AMENDMENT NO. 1 DECEMBER 2020

**IS 1293 : 2019 PLUGS AND SOCKET-OUTLETS
FOR HOUSEHOLD AND SIMILAR PURPOSES
OF RATED VOLTAGE UP TO AND INCLUDING
250 V AND RATED CURRENT UP TO AND
INCLUDING 16A — SPECIFICATION**

(Fourth Revision)

FIG. 1C COMBINED SOCKET-OUTLETS'

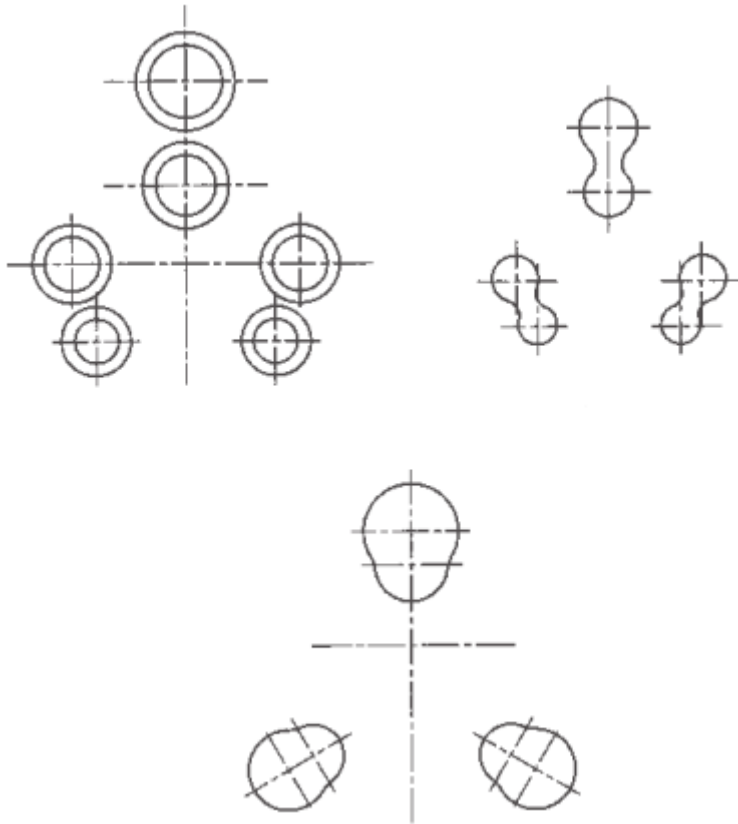
(Page 3, Fig. 1) — Substitute the following for the existing:

FIG. 4 SADDLE TERMINALS

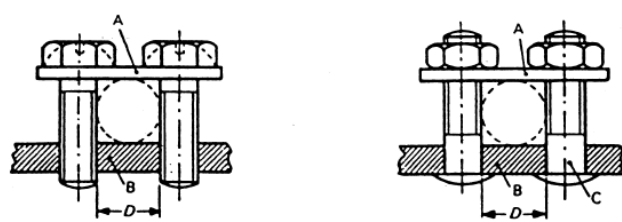
(Page 7, Fig. 4) — Substitute the following for the existing:

- Key
- A = Saddle
 - B = Fixed part
 - C = Stud
 - D = Conductor Space

<i>Cross-section of Conductor Accepted by the Terminal (mm²)</i>	<i>Minimum Diameter D of Conductor Space (mm)</i>	<i>Torque Nm</i>
Up to 4	3.0	0.5
Up to 6	4.0	0.8
Up to 10	4.5	1.2

The shape of the conductor space may differ from that shown in the figure, provided that a circle with a diameter equal to the minimum value specified for *D* can be inscribed.

The shape of the upper and lower faces of the saddle made different to accommodate conductors of either small or large cross sectional areas by inverting the saddle.

FIG. 5 MANTLE TERMINALS

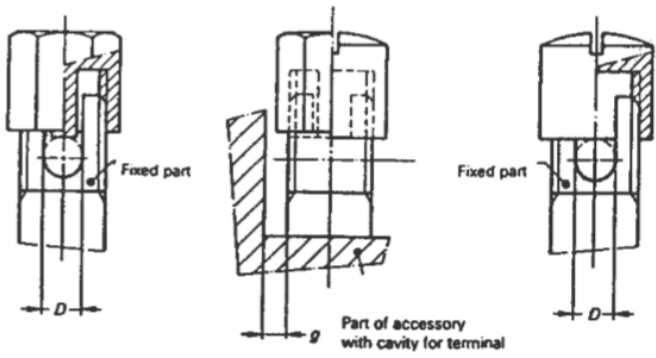
(Page 8, Fig. 5) — Substitute the following for the existing:

<i>Cross-Section of Conductor Accepted by the Terminal</i>	<i>Minimum Diameter D of Conductor Space ¹⁾</i>	<i>Minimum Distance g Between Fixed Part and End of Conductor When Fully Inserted</i>
(mm ²)	(mm)	(mm)
Up to 1.5	1.7	1.5
Up to 2.5	2.0	1.5
Up to 4	2.7	1.8
Up to 6	3.6	1.8
Up to 10	4.3	2.0
¹⁾ The bottom of the conductor space must be slightly rounded in order to obtain a reliable connection.

NOTE — The value of the torque to be applied is that specified in col 4 or col 5 of Table 1 as appropriate.

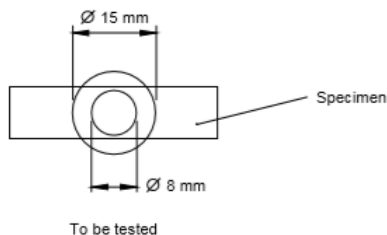
(Page 73, clause **28.1.1**, para 6) — Substitute the following for the existing:

‘Small parts, where each surface lies completely within a circle of 15 mm diameter, or where any part of the surface lies outside a 15 mm diameter circle and where it is not possible to fit a circle of 8 mm diameter on any of the surfaces, are not subjected to the test of this sub clause. Diagrammatic representation is as shown below:

NOTE — When checking a surface, projections on the surfaces and holes which are not greater than 2 mm on the largest dimension are disregarded.’
